## Determination 2011/063

### Regarding a notice to fix issued for 8-year-old additions and alterations to a house at 15 Lingarth Street, Remuera, Auckland

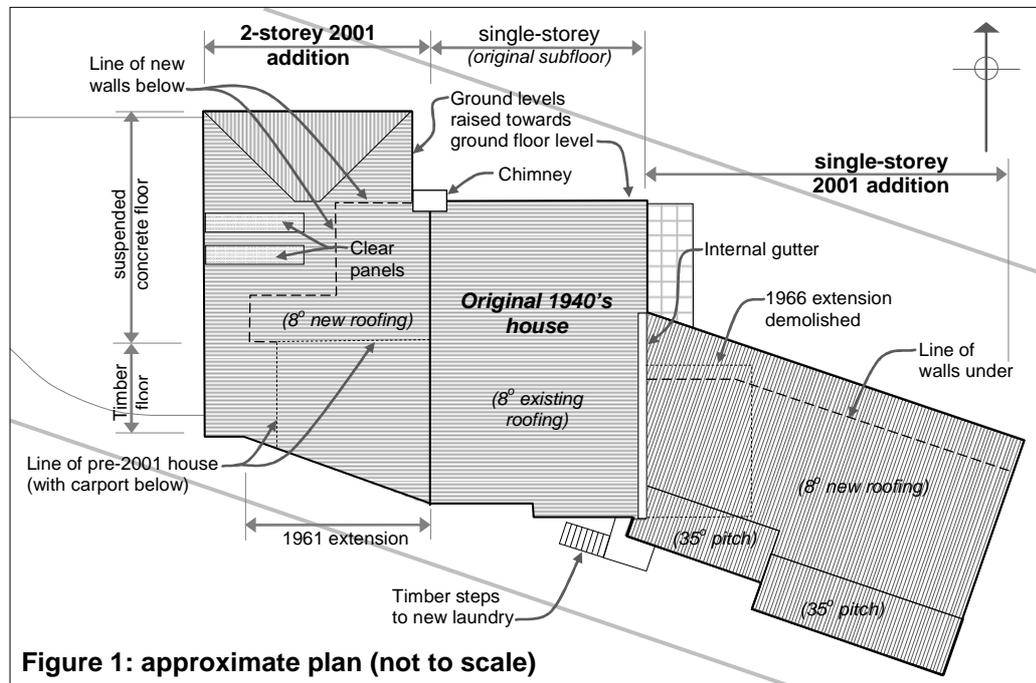
2.3.1 The subject alterations included significant additions to the west and east of the house as shown in the site plan sketch in Figure 1:

2.3.2 The west addition included:

- demolition of the 1961 decks and carport retaining wall
- the construction of a new basement level to provide:
  - a double garage to the northwest
  - a new basement entry foyer and stairs to the upper level
- alterations of the existing carport area to provide:
  - concrete block column, lintel and balustrade at west end of carport
  - a new timber-framed deck floor, new timber posts under the existing master bedroom and a clad balustrade to the south end of the deck
- additions to the upper level to provide:
  - an extended living room
  - a new concrete floor deck over the basement
  - a new roof extending to the edge of the new deck.

2.3.3 The east addition included:

- demolition of the 1966 east extension
- a large new wing to provide a new laundry and toilet and three additional bedrooms opening off a playroom.
